Subject: **MHI's Response to US-APWR DCD RAIs No. 939-6334 Revision 3 (SRP 03.07.01) and No. 940-6532 SRP (03.07.01)**

Response to Request for Additional Information No. 939-6334
Revision 3

US-APWR Design Certification

RAI NO.:	**NO. 939-6334, REVISION 3**
SRP SECTION:	**03.07.01 – Seismic Design Parameters**
APPLICATION SECTION:	**3.7.1**
DATE OF RAI ISSUE:	**06/12/12**

Figure 1, Comparison of Median Estimates for Strain Compatible Properties (shear-wave velocity, compressional-wave velocity, shear-wave damping, compressional-wave damping) Developed for 60 and 30 Realizations for 500 ft Deep Profile 560-500

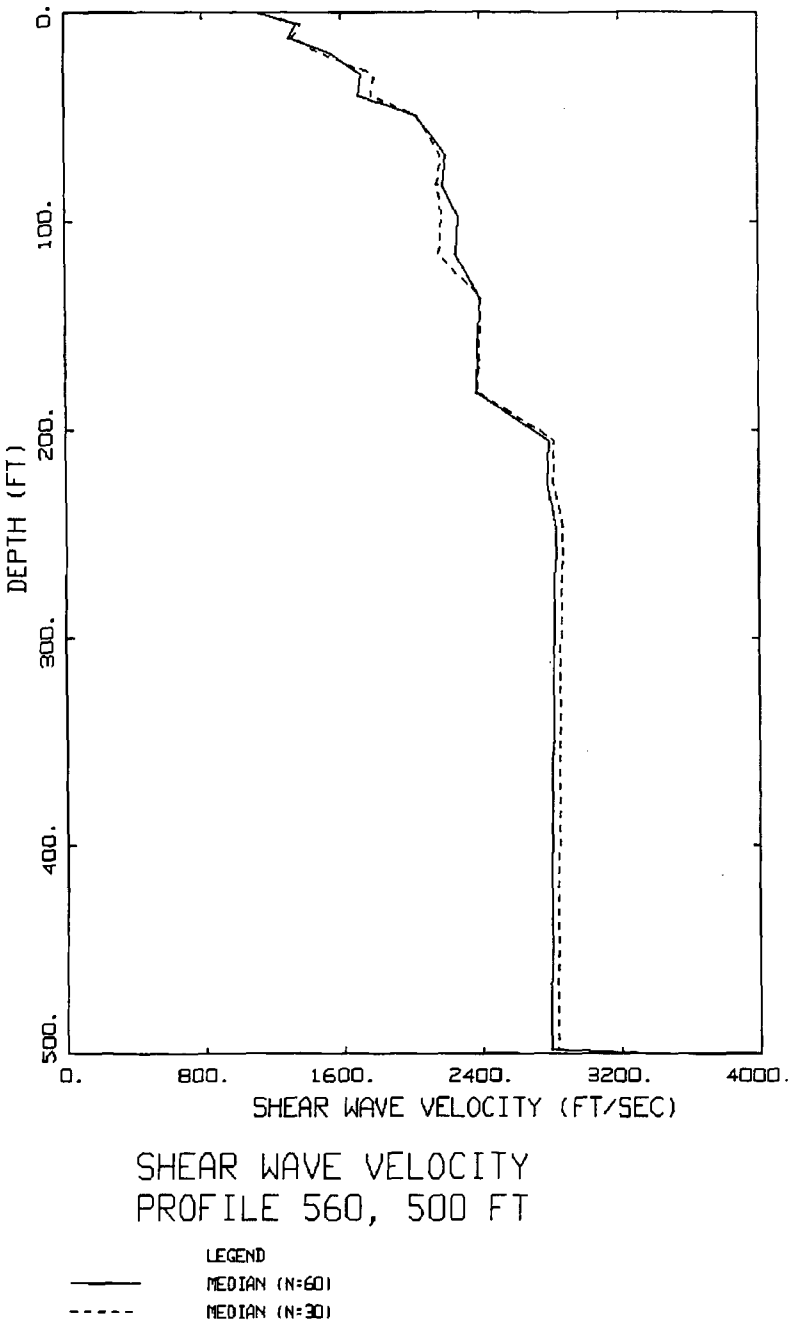
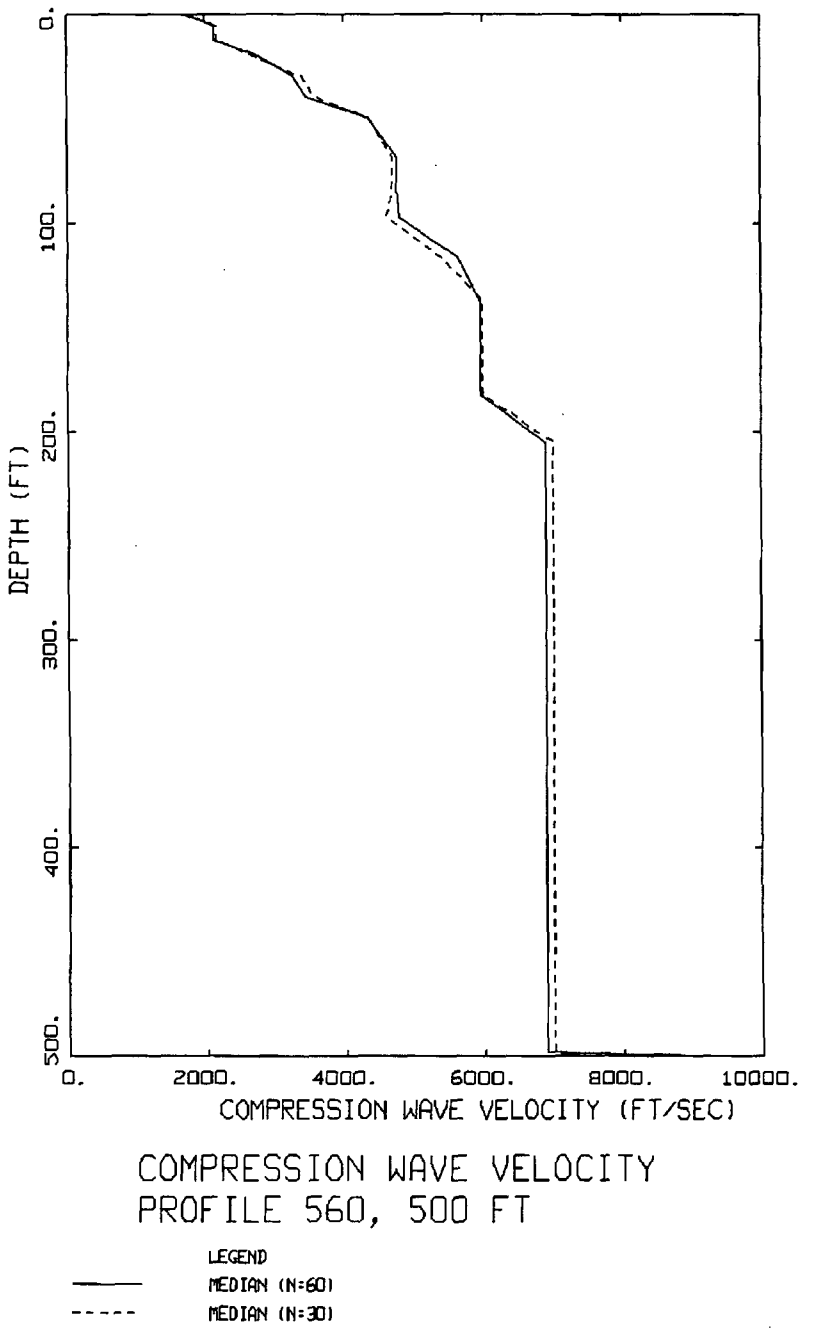
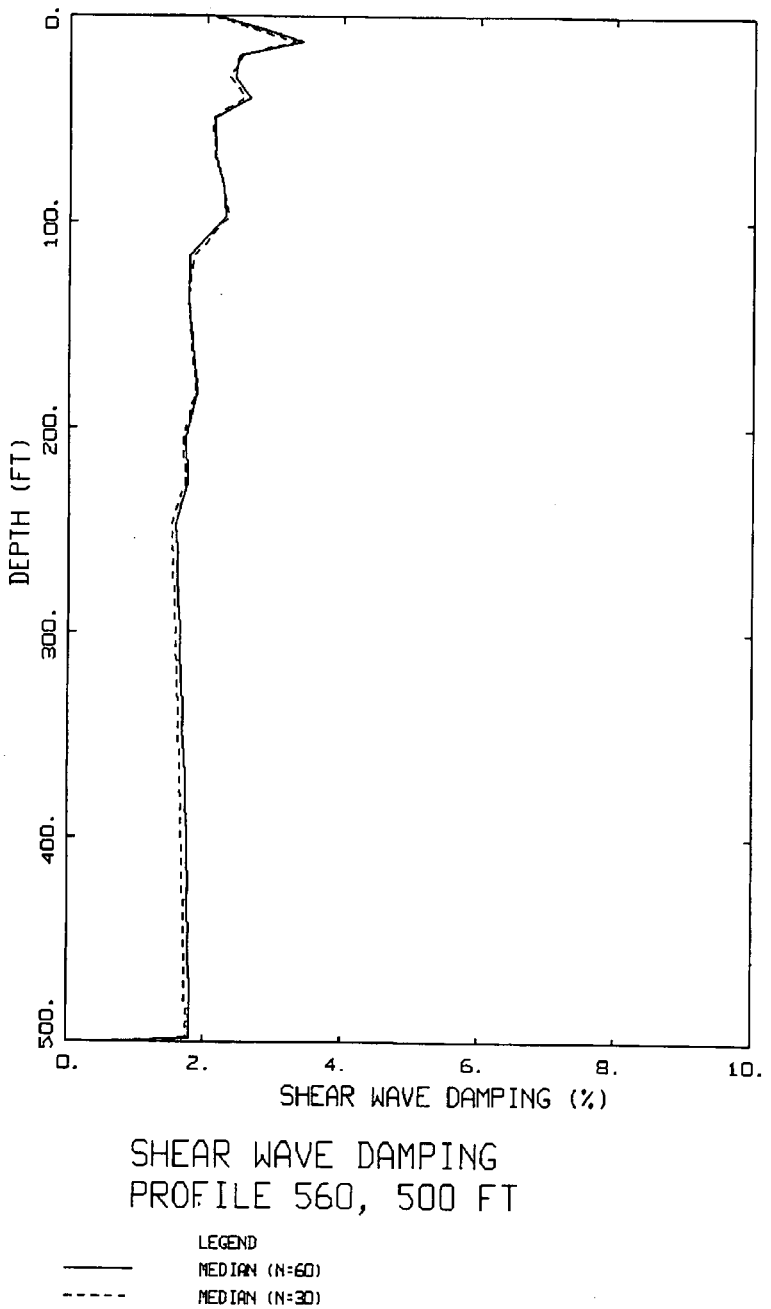
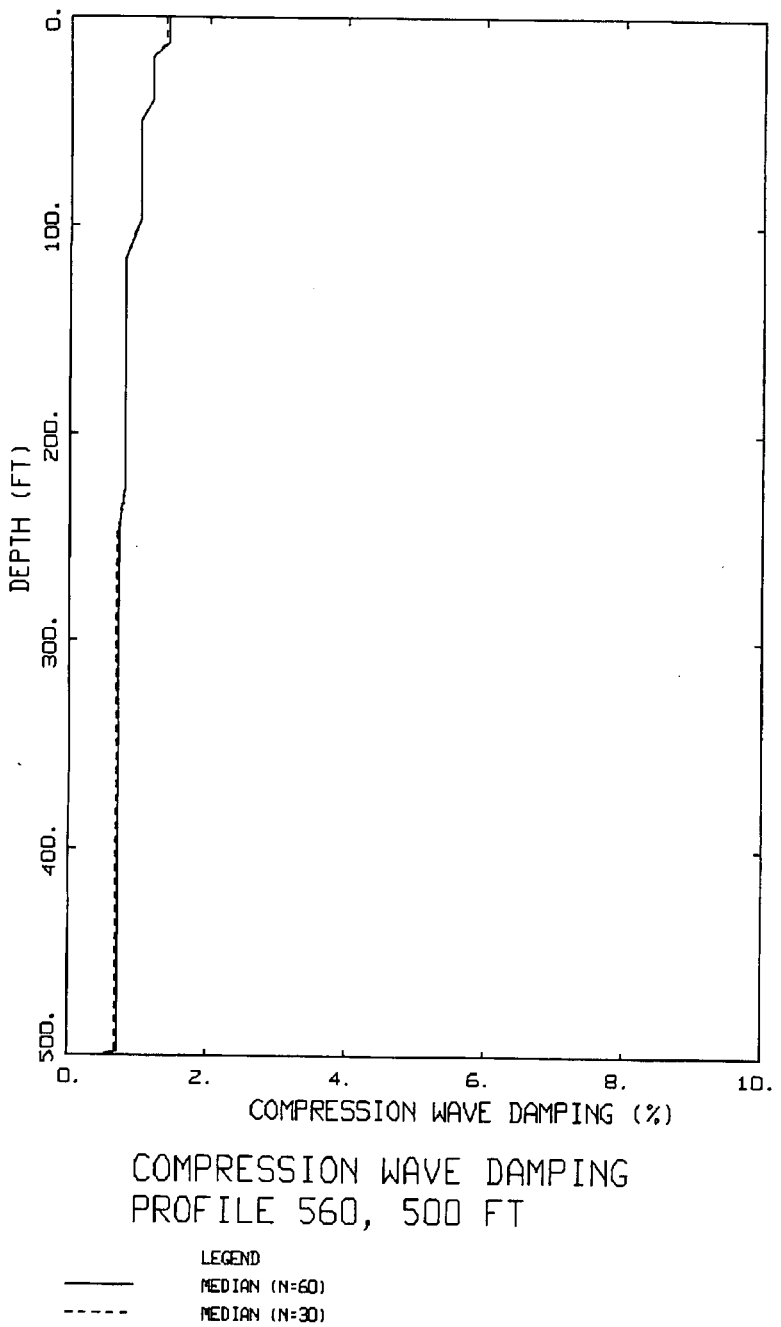
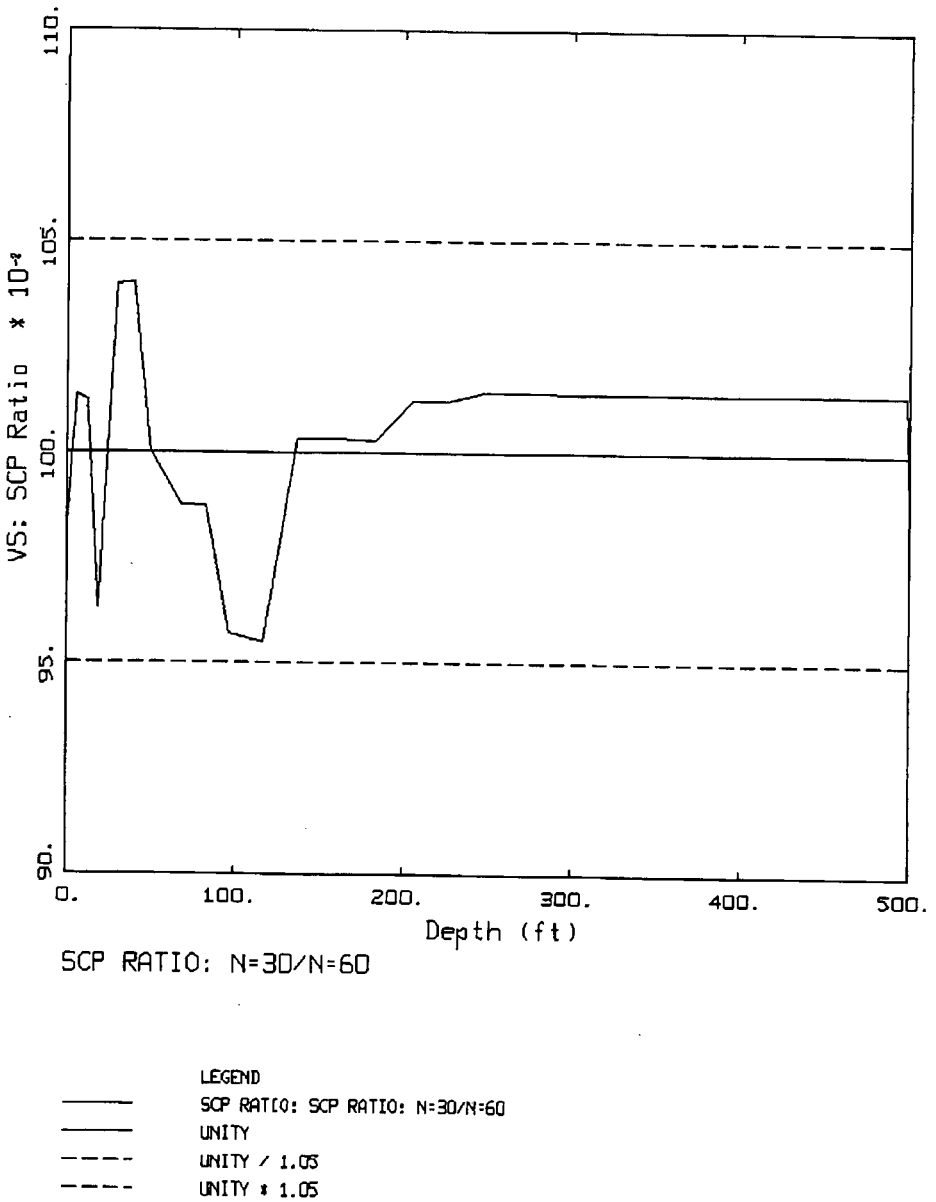
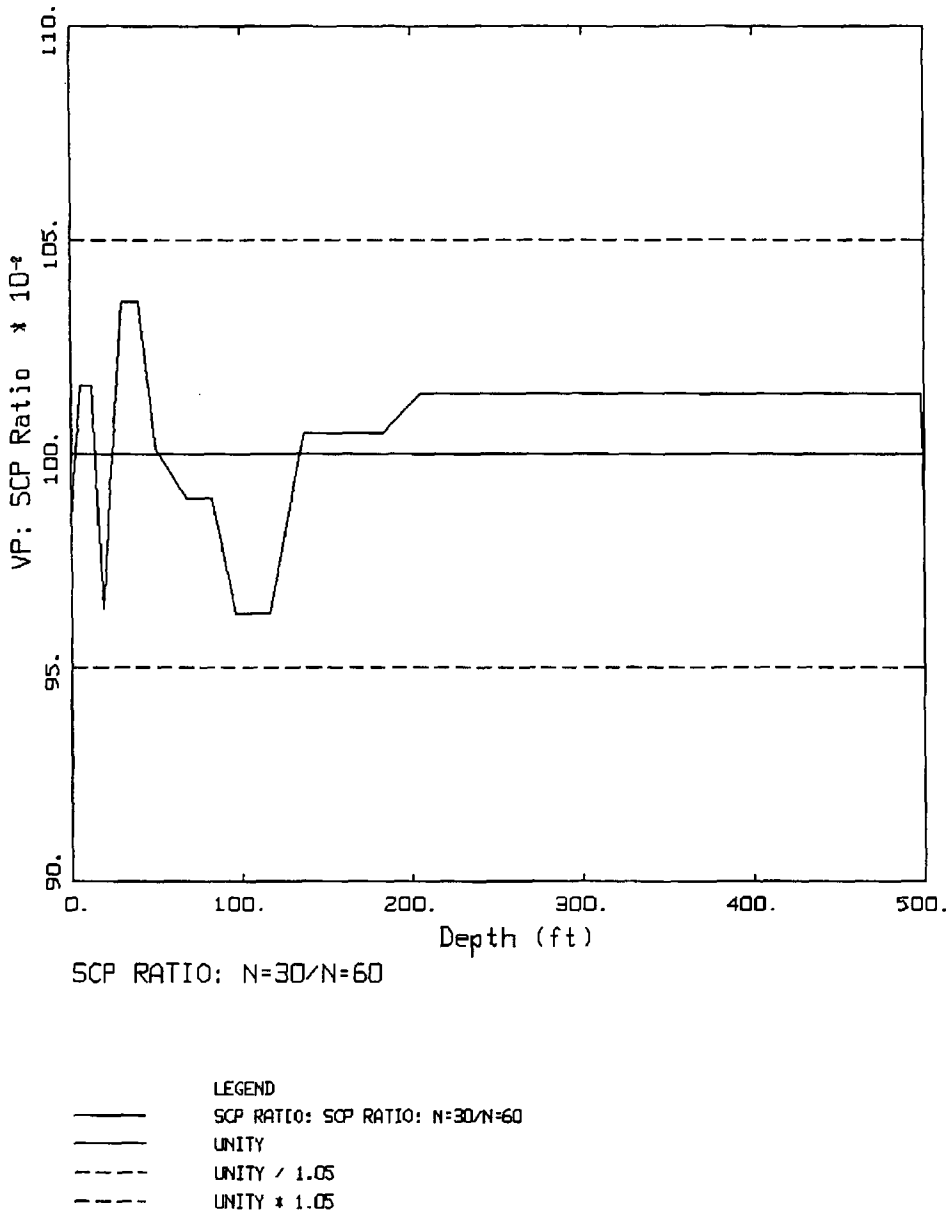
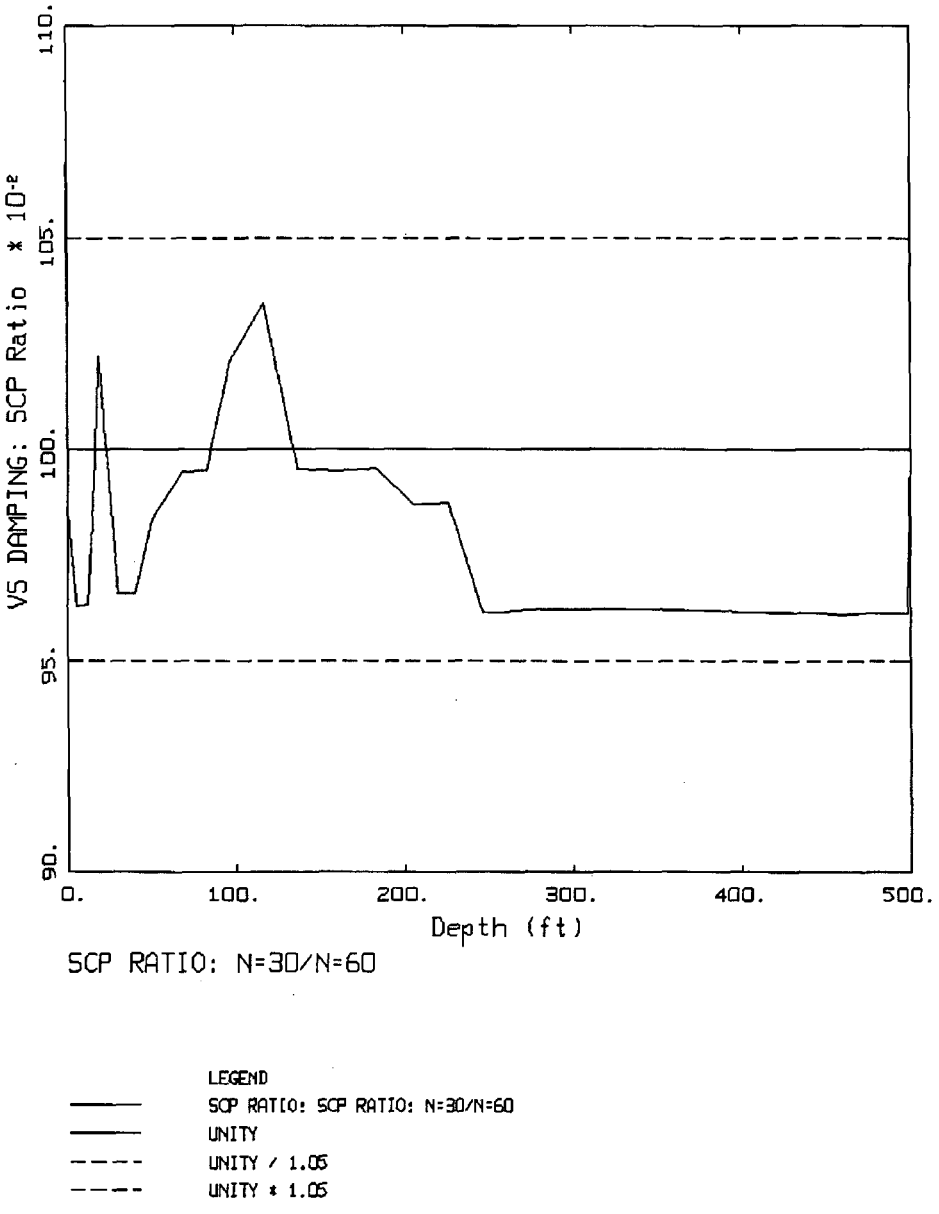
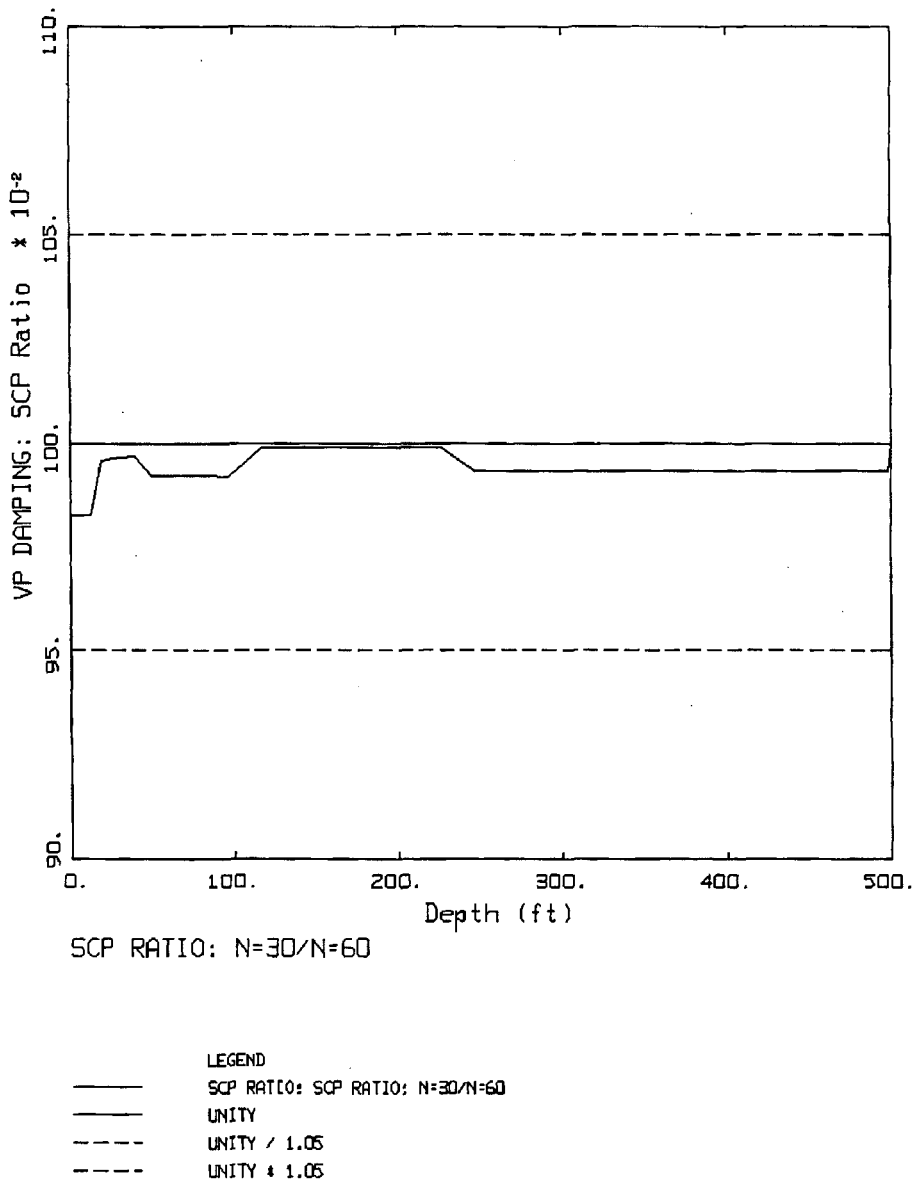
In its response to RAI 850-6002, Question No. 03.07.01-22, the applicant provides Table 1 which is taken from a source of standard statistical tables. Table 1 shows the sample size required for a given percent error in the standard deviation for a normal distribution, which the applicant purports to support their assertion that using 30 realizations in the analyses provides sufficient stable estimates of means and standard deviations. Further, the applicant states that increasing the sample size to 60 realizations reflects, at best, only an unnecessary and marginal improvement.

The staff considers that the evidence provided in Table 1 to be inadequate for supporting the applicant's argument. The staff is requesting that the applicant use actual data generated from the soil profiles in the US-APWR DCD; provide a table that shows conclusively the convergence as the number of realizations is increased; and provide the rationale to support the claim that 30 realizations instead of 60 realizations as specified in RG. 1.208 is adequate for the analyses.

MHI's position is that increasing the sample size from 30 to 60 reflects a marginal improvement to the accuracy of the strain compatible properties that are developed as median value of the results obtained from site response analyses of 30 realizations.. In order to illustrate the numerical stability in strain compatible properties between 30 and 60 realizations, Figure 1 compares median strain compatible property estimates computed for the two sample sizes for the deep (500 ft) generic profile 560 - 500. Figure 2 provides ratios of the property estimates, i.e., 30 realizations/60 realizations for all properties (shear-wave and compressional-wave velocities and corresponding damping). The maximum difference is about 5% and occurs over shallow and narrow depth ranges. Over the deeper portion of the profile, beyond a depth of about 150 ft, the difference is about 2% in shear-wave and compressional-wave velocity and about 4% in shear-wave damping.

A similar stability of 30 versus 60 realizations is provided for the standard deviation. Figure 3 is a plot, corresponding to the plot in Figure 1, for the Standard Deviations (sigmas) of the strain compatible properties. The percent difference between 30 verses 60 realizations is slightly larger

for sigma compared to the mean (Figures 1 and 2), as expected from standard statistical tables. These results support the position, based on standard statistical tables, that the difference in estimates of means and standard deviations is not significant between sample sizes of 30 and 60. The guidance in RG 1.208 for 60 realizations refers to the standard deviation of the simulated response spectra, which is not used in developing the strain compatible properties. The demonstration of stability of the strain compatible properties sigma estimates with respect to sample sizes of 30 versus 60 is offered to provide additional clarity in the process of developing the strain compatible properties.

As illustrated in the figures below, there are marginal improvements in increasing the sample size from 30 to 60. Therefore using 30 realizations is sufficient to provide reasonable estimates for the mean generic strain compatible properties used as input for the site-independent soil-structure interaction (SSI) analyses.
